**VILLAGE OF TUSCARAWAS  
TUSCARAWAS COUNTY, OHIO**

**WATER SYSTEM IMPROVEMENTS**

**ADDENDUM #2**

**APRIL 1, 2021**

SHEET No.  
**P1**

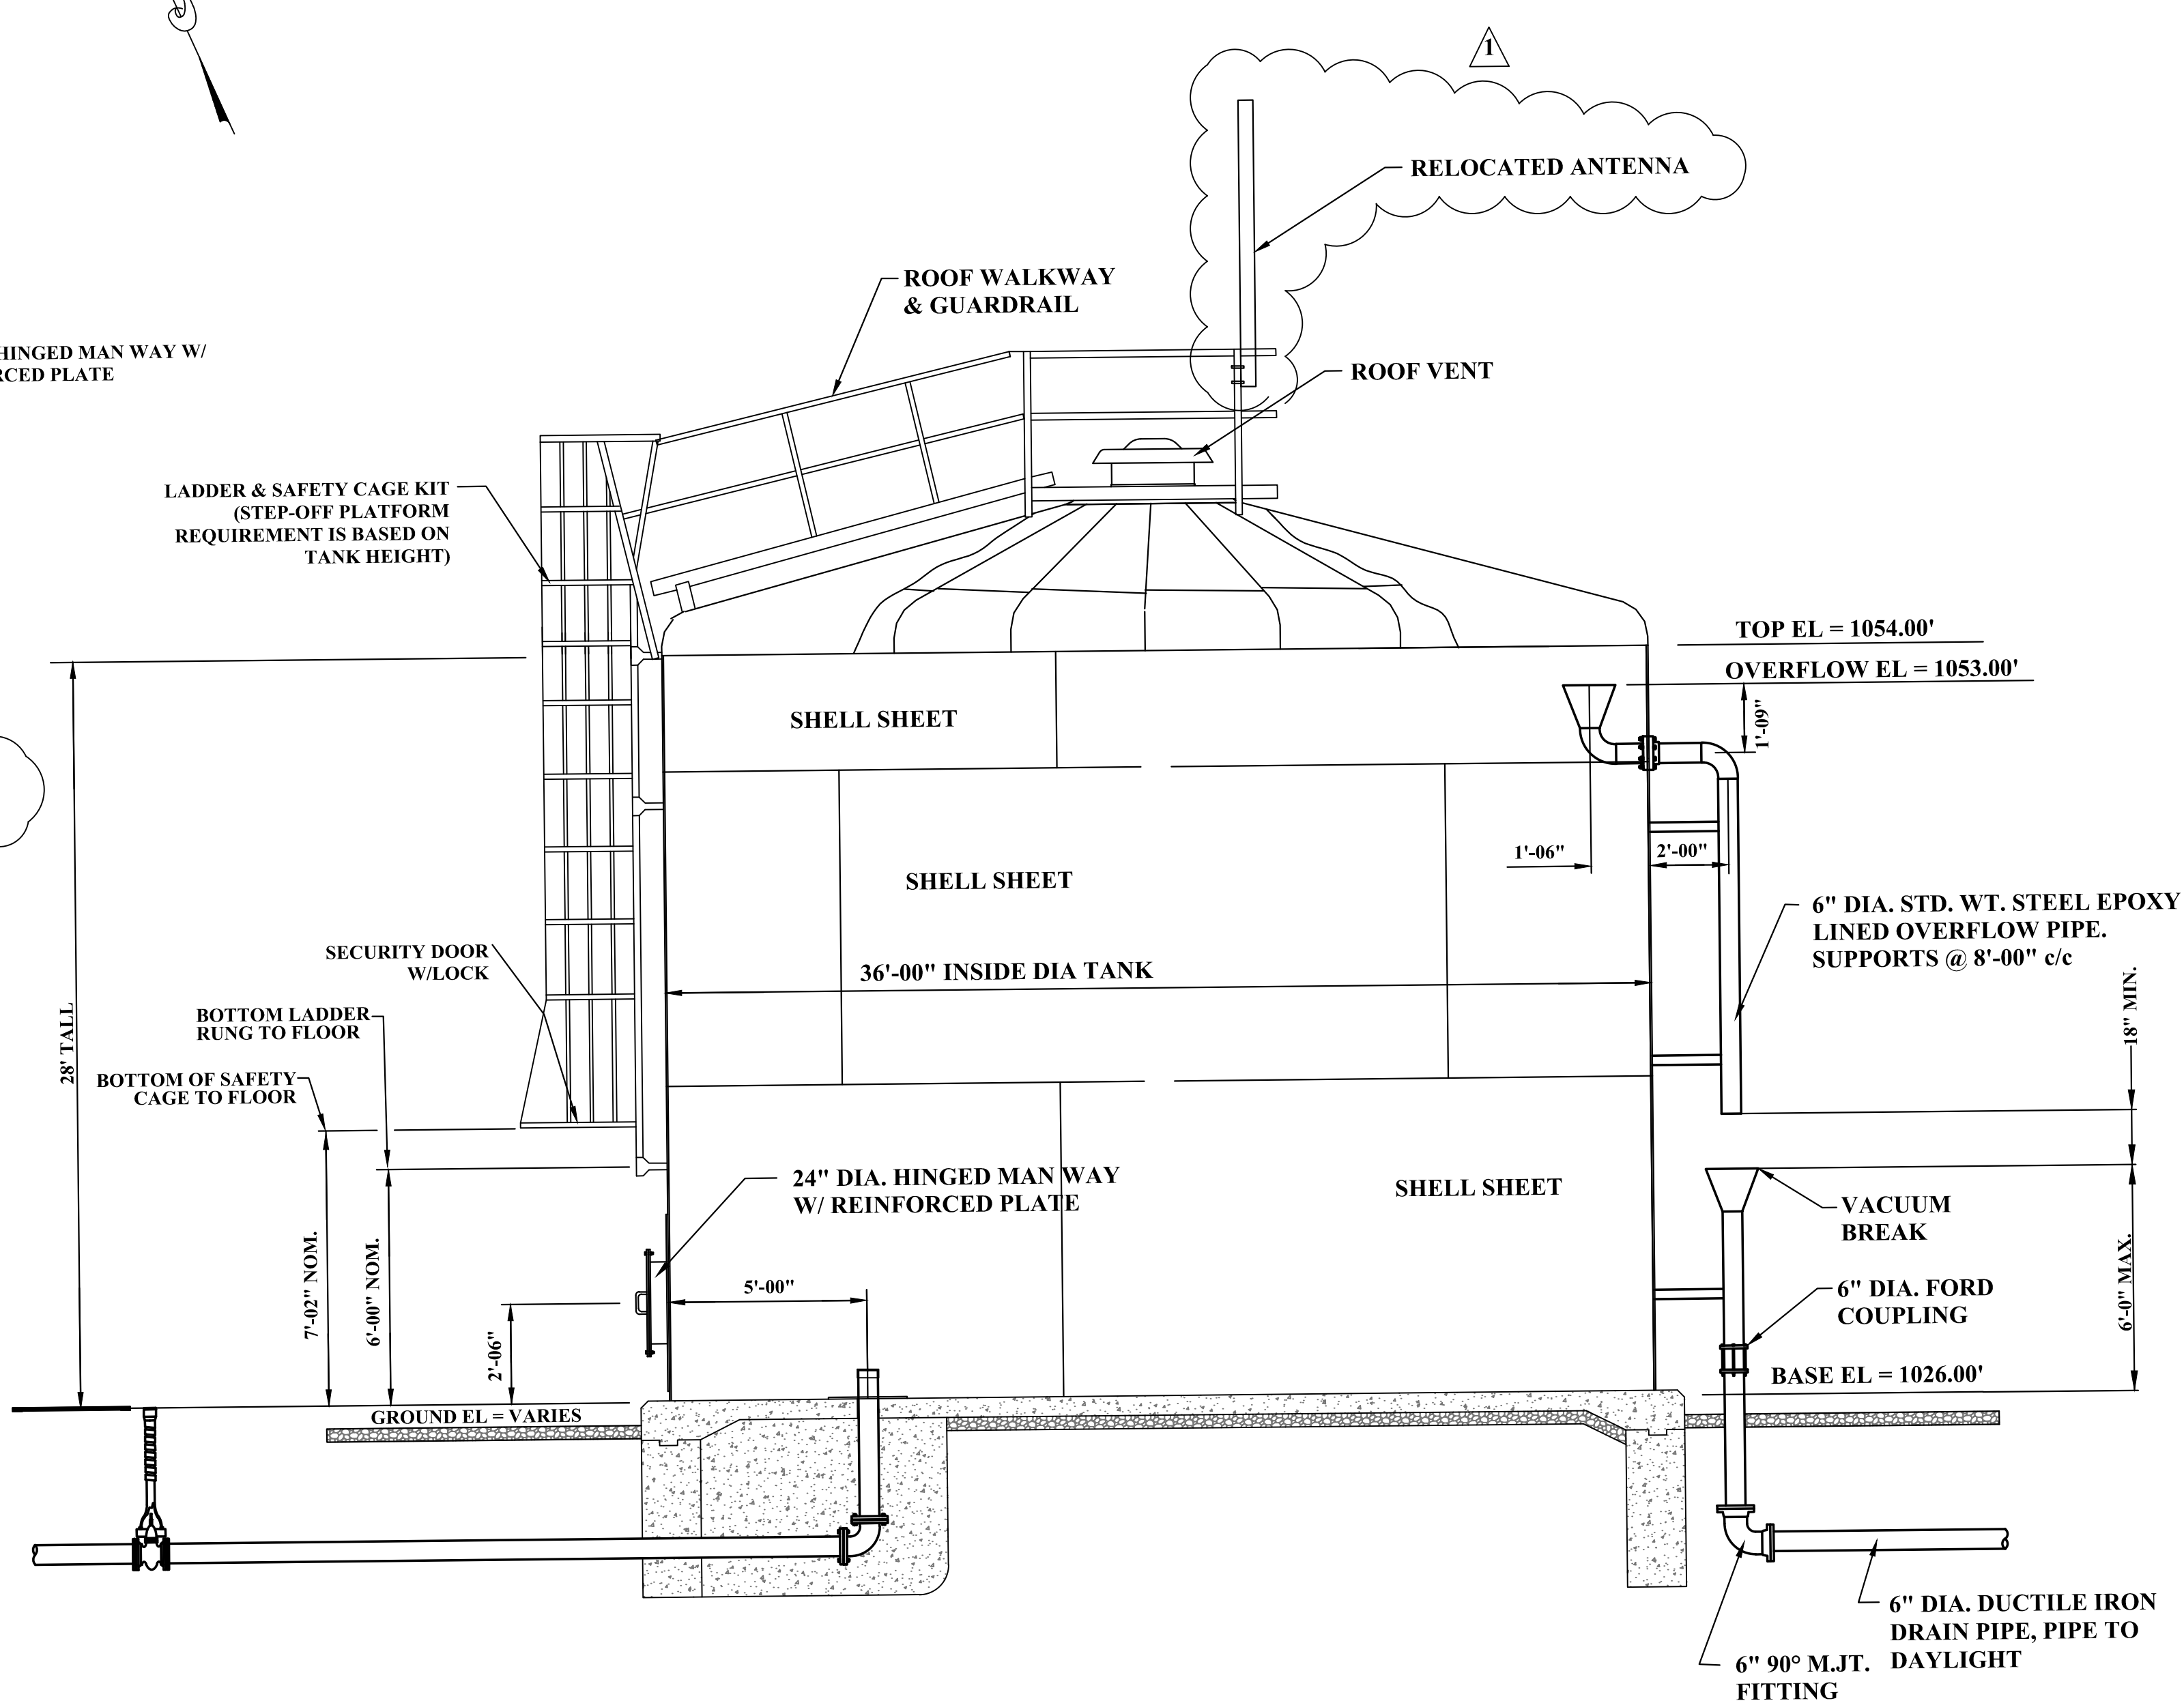
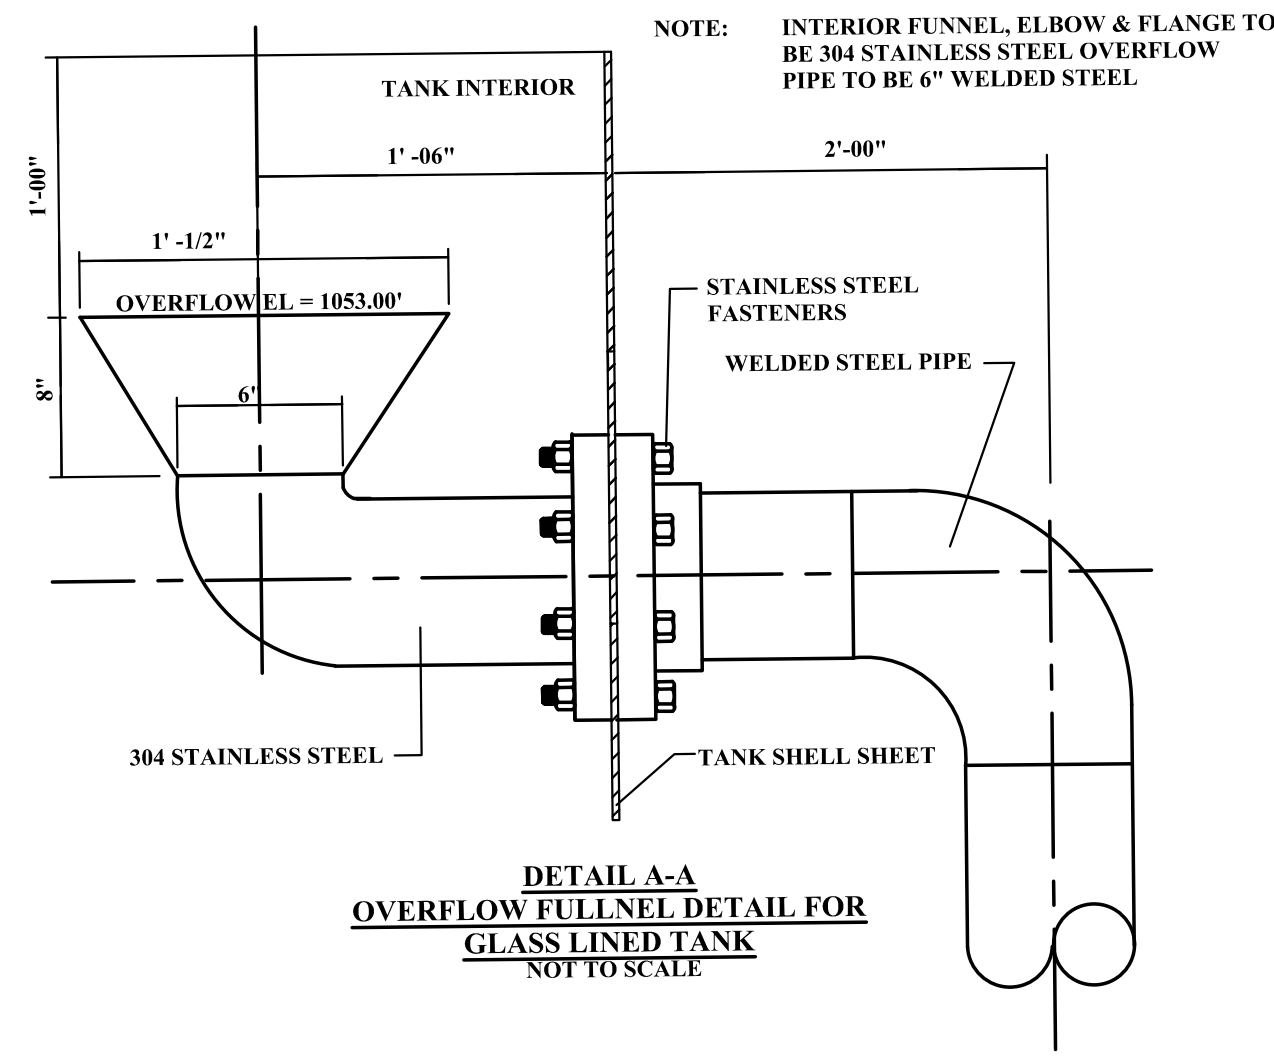
1. Plan Sheet P1 was revised, added notes number five through eight. Revised Plan Sheet P1 is attached to Addendum.
2. Plan Sheet P2 was revised. Revised Plan Sheet P2 is attached to Addendum.
  - a. Notes 6-7 added to “Glass-Lined Tank Foundation Detail.”
  - b. Revised “Glass-Lined Tank Foundation Detail” to show revised foundation material/subgrade.

**GLASS-LINED TANK FOUNDATION DETAIL**

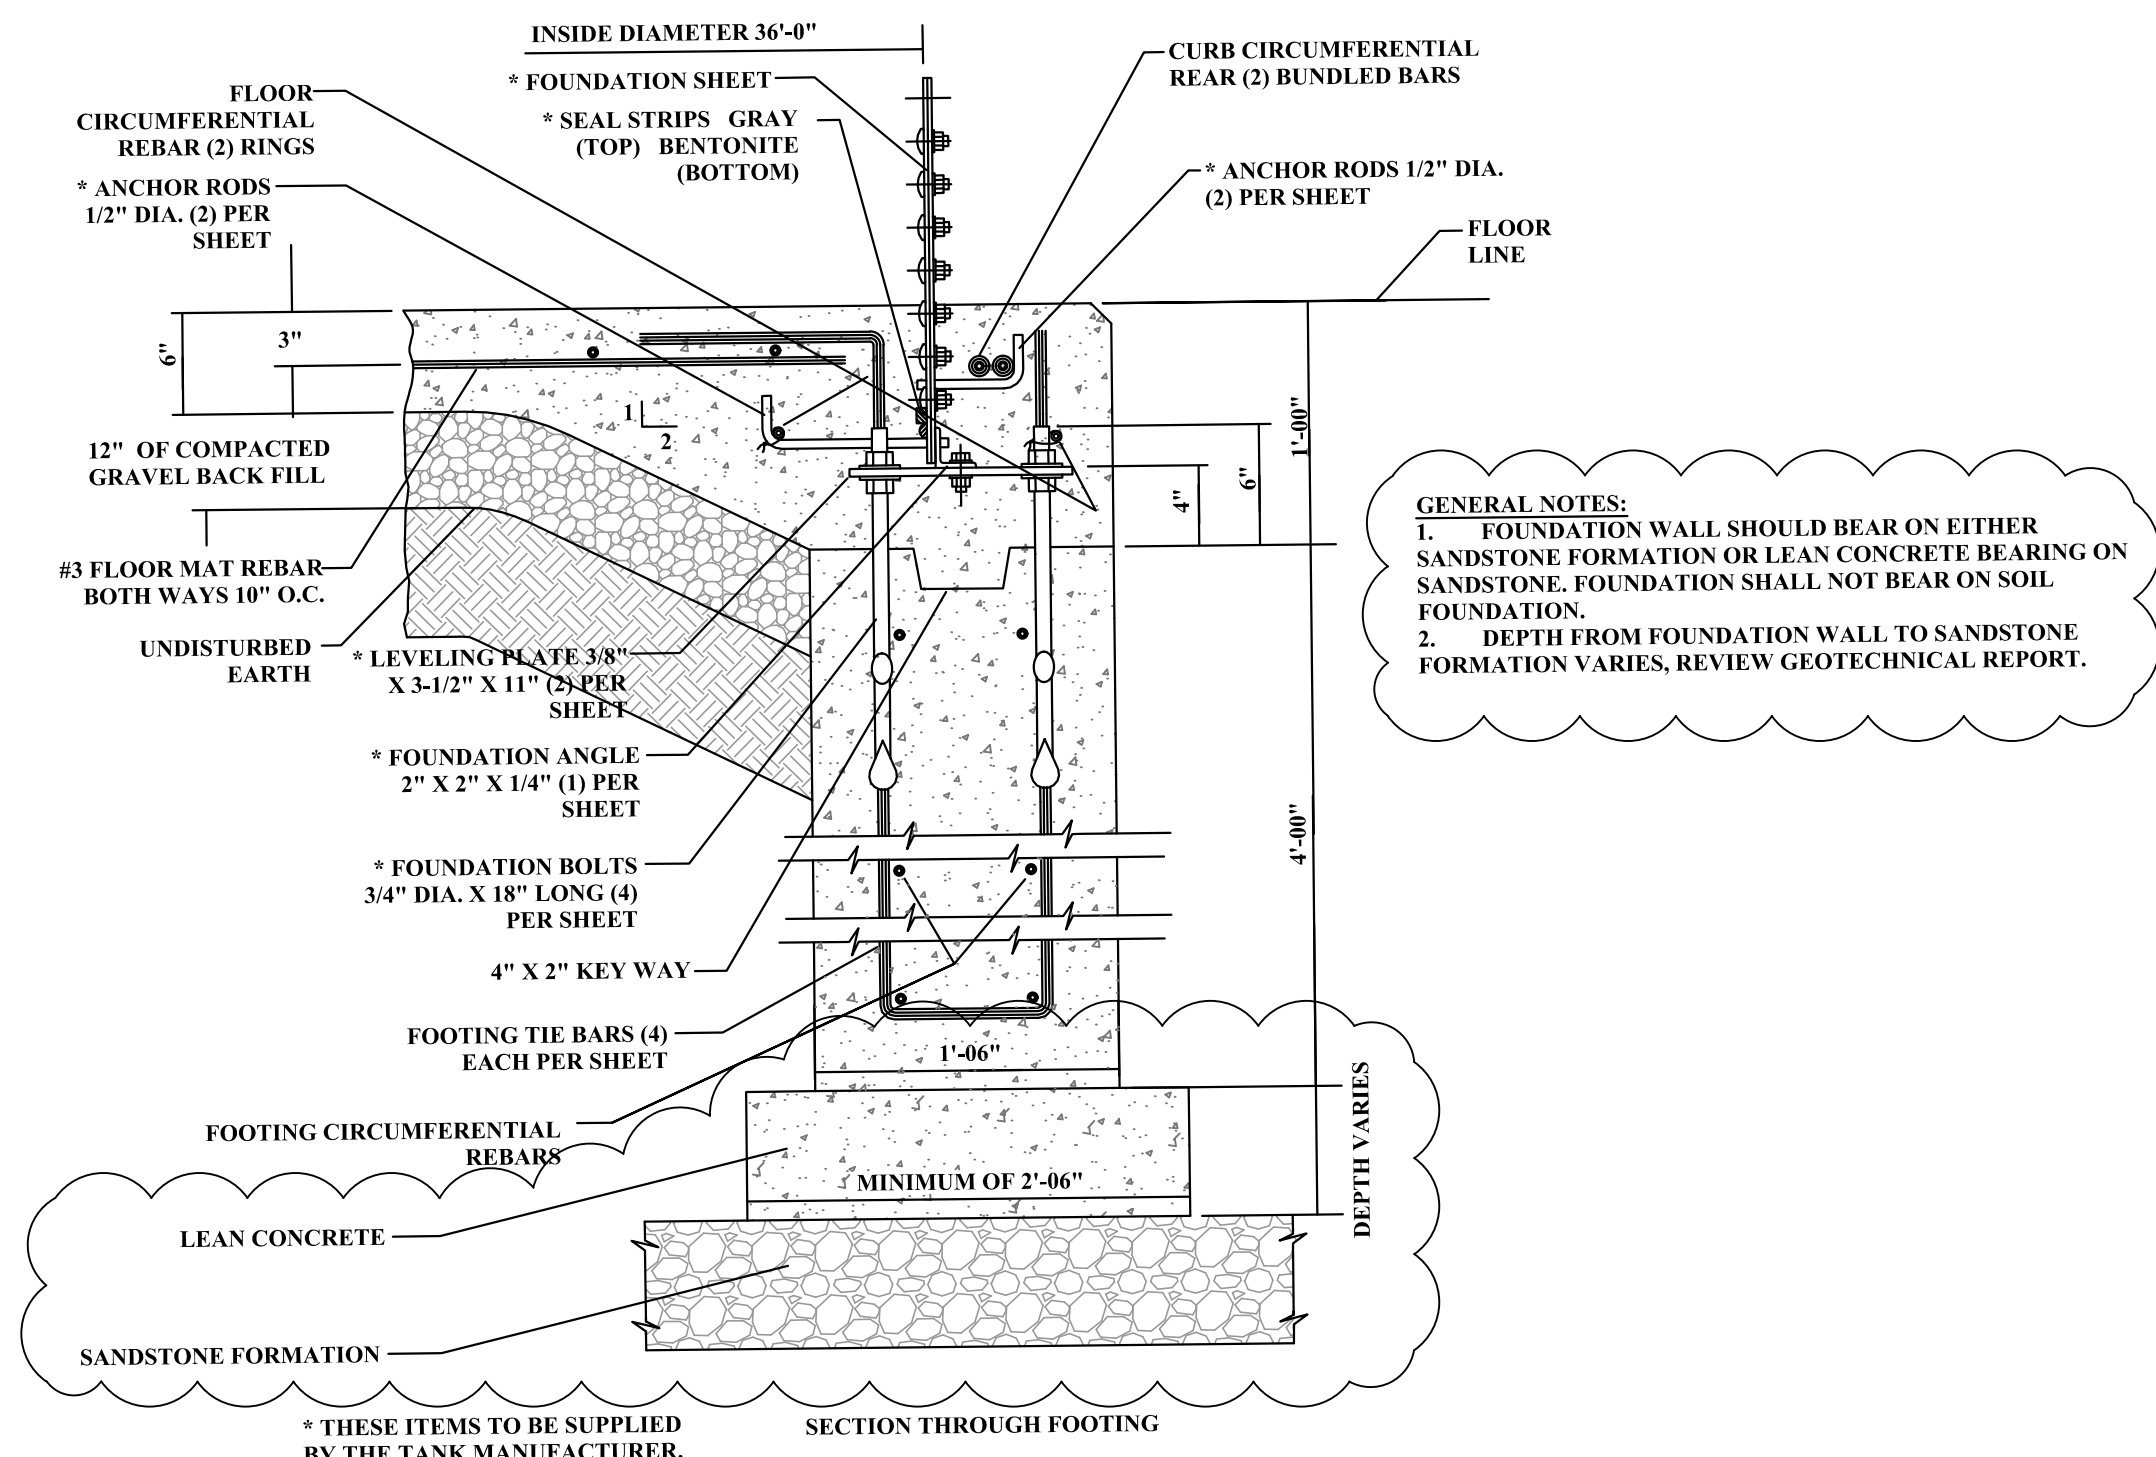
1. The geotechnical report has the ringwall footing bearing 3.5 feet below grade. The project drawings show 4.5 feet. Can the ringwall depth be clarified?

The ringwall dimensions shown on the Glass-Lined Tank Foundation Detail on sheet P2 are to be used over any other dimensions given in the geotechnical report or elsewhere.
